**PLANNED UNIT DEVELOPMENT &  
SUBDIVISION STAFF REPORT****Date: August 6, 2015****NAME**

Southport Industrial Estate, LLC Subdivision

**LOCATION**4077 Hamilton Boulevard  
(South side of Hamilton Boulevard, 2/10± mile West of  
Rangeline Road).**CITY COUNCIL  
DISTRICT**

**CONTEMPLATED USE**Subdivision to create two legal lots of record, and Planned  
Unit Development Approval to allow multiple buildings on  
a single building site**TIME SCHEDULE**

# SITE PLAN

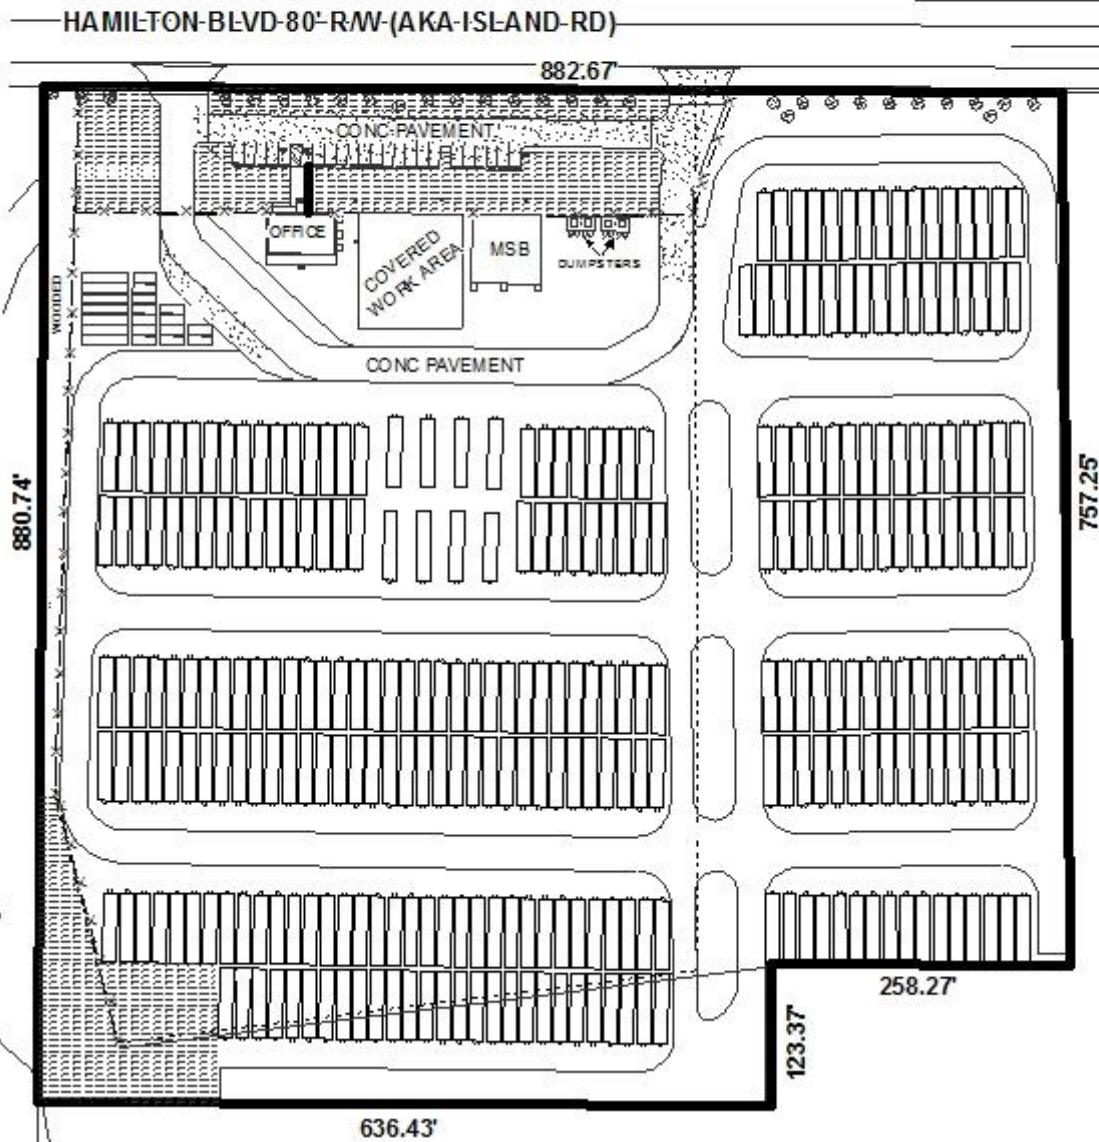
The applicant wishes to create two legal lots of record from two metes-and-bounds parcels. It should be noted however, that the preliminary plat submitted appears to be including a portion of a parcel to the South of the site (R023801380000035.) which does not appear to be owned by the applicant. If this is accurate, the applicant should revise the application to include the entire parcel to the South, and submit revised application fees, mailing labels, and appropriate authorization.

The proposed lots, as depicted, meet the minimum size and frontage requirements as regulated by the Subdivision Regulations. The lot area sizes are depicted on the plat in square feet and acres. The lot sizes should be retained in square feet and acres on the Final Plat, if approved. The 25-foot minimum building setback line is not depicted, and should be illustrated on the Final Plat, if approved.

The lot fronts Hamilton Boulevard, a proposed major street, which should have a right-of-way of 100'. The preliminary plat illustrated an existing right-of-way width of 80', making dedication necessary to provide 50' from the centerline. As a means of access management, a note should be placed on the site plan and Final Plat stating that Lot 1 is limited to the two existing curb cuts to Hamilton Boulevard, and Lot 2 is limited to one curb cut to Hamilton Boulevard with size, location and design to be approved by Traffic Engineering and conform to AASHTO standards.

The proposed Lot 1 currently operates as a shipping container storage yard and will be developed with three structures. The site plan submitted states that one structure will be used as office space, but does not provide the use of the other two structures. The use of all structures and number of warehouse employees, if applicable, should be provided so that staff can determine if the proposed 23 parking spaces are sufficient.

- 1) revision of the preliminary plat to either include the entire parcel to the South (R023801380000035.), or remove the included portion; and
- 2) submittal of revised fees, mailing labels, and appropriate authorization, if necessary.

- 1) provide the uses of the existing structures on site and number of warehouse employees, if applicable.
